Multiple Patterns of Features¹

This part has two patterns of holes that are required to be treated as one composite pattern. They are to be located to common datum features with a \emptyset .010 cylinderical tolerance zone. They must also to be located to each other, perpendicular to datum feature A, and parallel to datum feature B with a \emptyset .002 cylinderal tolerance zone as a refinement to the \emptyset .010 location control.

Figure 1

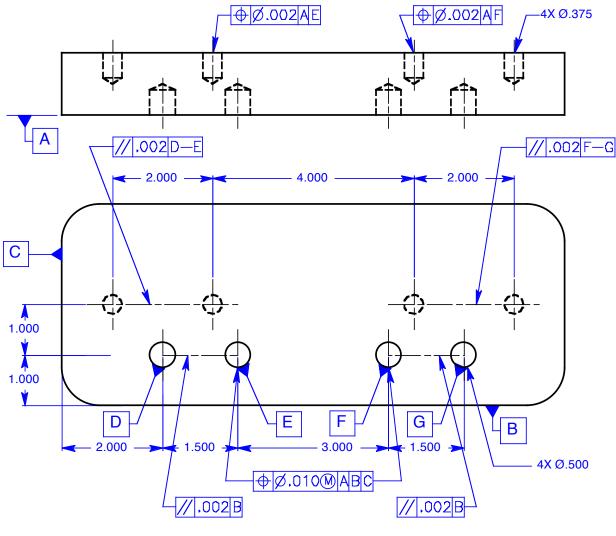
There are several problems with this drawing. First, the hole locating dimensions must be basic. Second, the position tolerances should be associated with the size dimension of the features. Third, a tolerance is never applied to imaginary lines or planes such as center planes between features. And finally, the $\frac{1}{2}$ inch holes are toleranced parallel to datum feature B within a tolerance of .002 at RFS, but only toleranced perpendicular to datum feature A within a Ø.010 cylinderical tolerance zone at MMC. The stated requirement is that the holes must be perpendicular to datum feature A and parallel to datum feature B within the smaller tolerance.

The tolerancing in Figure 2 is a much better solution to the drawing requirements. Since both hole patterns are located to the same datum features, in the same order of precedence, with basic dimensions, they are considered to be one composite pattern of features with respect to the upper segment of the composite feature control frame. That is, both patterns are located to datum features B and C and to each other within a cylindrical tolerance zone of \emptyset .010 at MMC. The lower segment of each feature control frame requires each hole to be located to every other hole in its respective pattern, perpendicular to datum feature A, and parallel to datum feature B within the smaller tolerance of \emptyset .002 at MMC. Since the simultaneous requirement note, SIM REQT, has been placed beneath each feature control frame, both patterns are to be treated as one composite pattern with respect to the lower segment of the feature Control frame. This means that all holes in both patterns are located to each other, perpendicular to datum feature A, and parallel to datum feature A, and parallel to datum feature B, and parallel to datum feature A, and parallel to datum feature A, and parallel to datum feature B within the same small tolerance; but at the same time, both patterns, treated as one composite pattern, are allowed to translate up and down and back and forth within the larger cylinderical tolerance zone \emptyset .010 at MMC.
